Memorandum

TO: District of Columbia Zoning Commission

DATE: September 28, 2015

SUBJECT: **ZC 15-07 – Final Report** Consolidated Planned Unit Development (PUD): 315 H Street NE (Square 777, Lots 24-28, 48 and 813-815).

Exhibit 31A1, Sheet A0.8

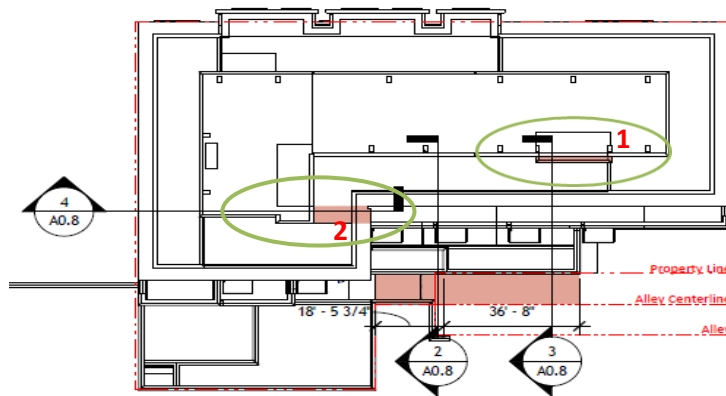
The revised plans include a 7-foot setback of the 7th and 8th floors at the rear. Further, the mechanical penthouse and the stair to the east (Stair #2) are not shown in one enclosure of equal height. Although the penthouse would meet required setbacks from the H Street facade, two areas at the rear of the building would not satisfy the 1:1 setback requirement (16 ft. 4" required), including:

1. One area along the south facade of the penthouse in the location of Stair #2 - 14 ft. 3 ins from the roof's edge; and
2. At the southeast area of the penthouse - 15 ft. 6 ins. from the roof's edge.

The penthouse structure should not be immediately visible from the public alley at the rear or from the sidewalk along the front of the building. The 7th and 8th floors are setback 7 feet from the roof's edge, and the penthouse would be a minimum of 38 feet from the rear property line. The alley's 20-foot width would create an effective separation of 56 feet from the closest alley-dwelling (Lot 87) at the rear (Exhibit 31A1, Sheet A0.8 – Rear Yard, Section 1 Plan). The penthouse and alley dwellings run parallel to each other, in an east west direction, where there are no direct views, so the penthouse should not be readily visible from these homes. Shadows should also not be detrimental to the residences, since the building would be to the north (See Exhibit 31A2 – Sheets A5.1, A5.2 - Shadow Studies). The proposed height and massing at 90 feet are shifted to the H Street frontage, where it would be consistent with the development height permitted under the PUD.

In the highlighted area #1 shown in the above diagram, the stair enclosure is lower in height than the mechanical penthouse, as it was shifted 2 feet outward from the main penthouse structure to accommodate design changes. As such, the massing would appear greater at the rear if the stair enclosure was unnecessarily made equal in height or included in one enclosure. Thus, separate enclosures for the mechanical and stair penthouses would be supported. OP considers the difference between the required and proposed setback to be minimal, so as not to impair the intent of the Regulations.

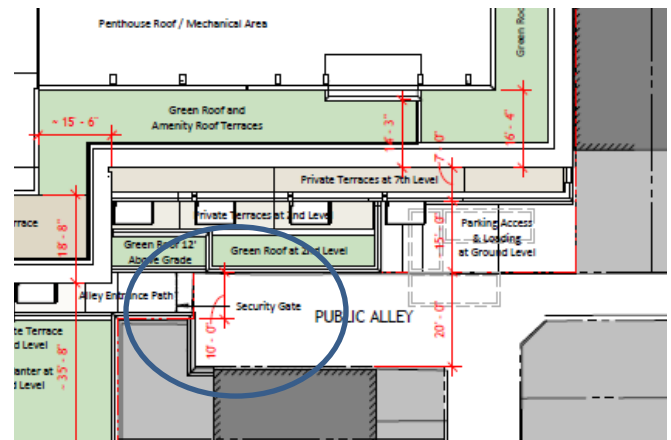
The Applicant previously requested flexibility in the design to provide one, 30-foot berth for residential use within the public alley space. However, the neighbor to the south of the proposed loading dock area at Lot 87 expressed the following concerns to OP including:

- Truck access through the narrow 10-foot wide alley;
- Truck turning movements;
- Noise;
- Concerns about pollution from idling trucks during delivery; and the
- Lack of showing by the applicant of the feasibility of loading within the property's boundaries.

These concerns were referred to the applicant and OP requested additional information, including various site designs to show why loading was not, or could not be included within the site given the recent 16-foot wide lot acquisition to the east of the original PUD site. The applicant subsequently modified the design to include an on-site, 24-foot residential loading dock with a supporting loading management plan, which is also intended to support off-site retail loading, proposed from the existing 4th Street loading area. (Exhibit 31A1, Sheet A1.3).

The loading management plan provided at Exhibit 12B1 is anticipated to mitigate vehicular conflicts with other alley users and reduce potential adverse impacts to the neighborhood. Generally, trucks accessing the alley would be limited to a maximum of 24 feet in length and move-in/out would be scheduled to use the dock. A loading manager would be hired to ensure the dock's capacity is not exceeded and to manage the inbound and outbound trucks through the 10-foot wide alley via 4th Street. It is not anticipated that move-in/move out would occur all at once, or as a constant activity. Periodically, when it would occur, it would be scheduled and managed by the building's management for trucks no larger than 24 feet in length. If DDOT is supportive of on-site loading proposed by the applicant, and its attendant loading management plan, then OP would support flexibility from the residential loading requirement.
